# RENESAS TECHNICAL UPDATE

Product Category	Transistor		Document No.	TN-TRS-A147A/E	Rev.	1.00
Title	Change of the die bonding material		Information Category	Change of packages		
Applicable Product	2SK1336,2SK1336-90TZ, 2SK1336-90TZ-E, 2SK1336-E,2SK1336TZ-E 2SD1922E90TZ,2SD1922E91TZ 2SK975-01TZ-E,2SK975-02TZ-E, 2SK975-90TZ,2SK975-E,2SK975-E-Q, 2SK975TZ,2SK975TZ-E,2SK975TZ-E-Q	Lot No.	Reference Document	Nothing		
		all

Fig1. Structure Drawing

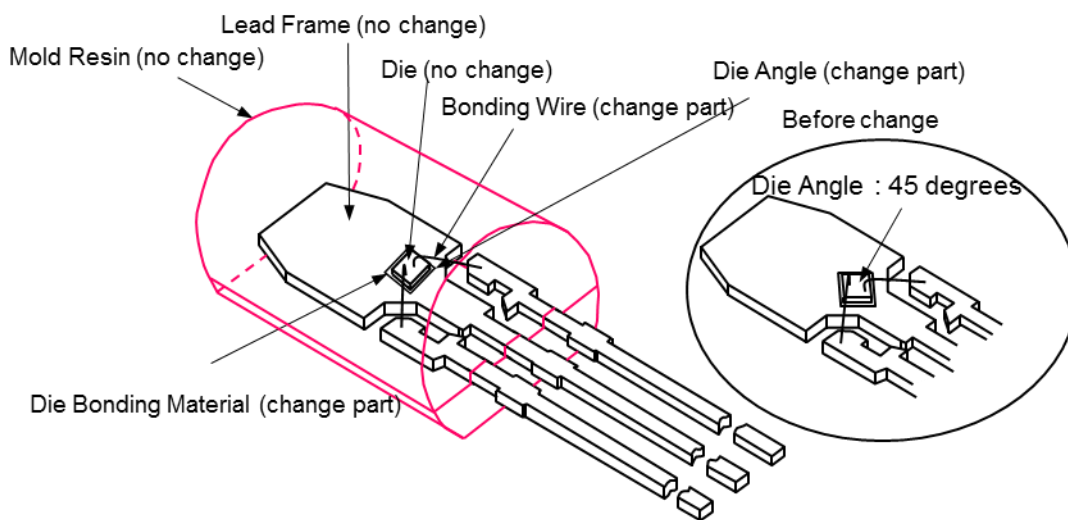
1. Reason Deterioration of gold foil supply equipment.
- 2.Contents Please refer to the following Fig 1 and Table 1. It will use the Silver paste in the future though these are produced on the gold foil paste for the die bonding material now. And the die angle changes along with the change of this die bonding material.
3. Schedule We will start the changes from Oct. 2013 gradually. Delivery of new or current versions depends on stock.
4. Remarks
  1. After change, there is no change of the guarantee electrical characteristic and the reliability of each product. Renesas Electronics Corp. is responsible for the product quality as usual before.
  2. The Silver paste is applied for TO-92,TO-92MOD of other transistor since the past and there are a lot of production results. It applies to the above-mentioned products this time though it has already applied to a part of TO-92,TO-92MOD product.

(note) Figure is an example of 2SK975.

Item	Current	After change
Die Bonding Material	Gold foil	Silver paste
Die Angle	45 degrees	0 degrees
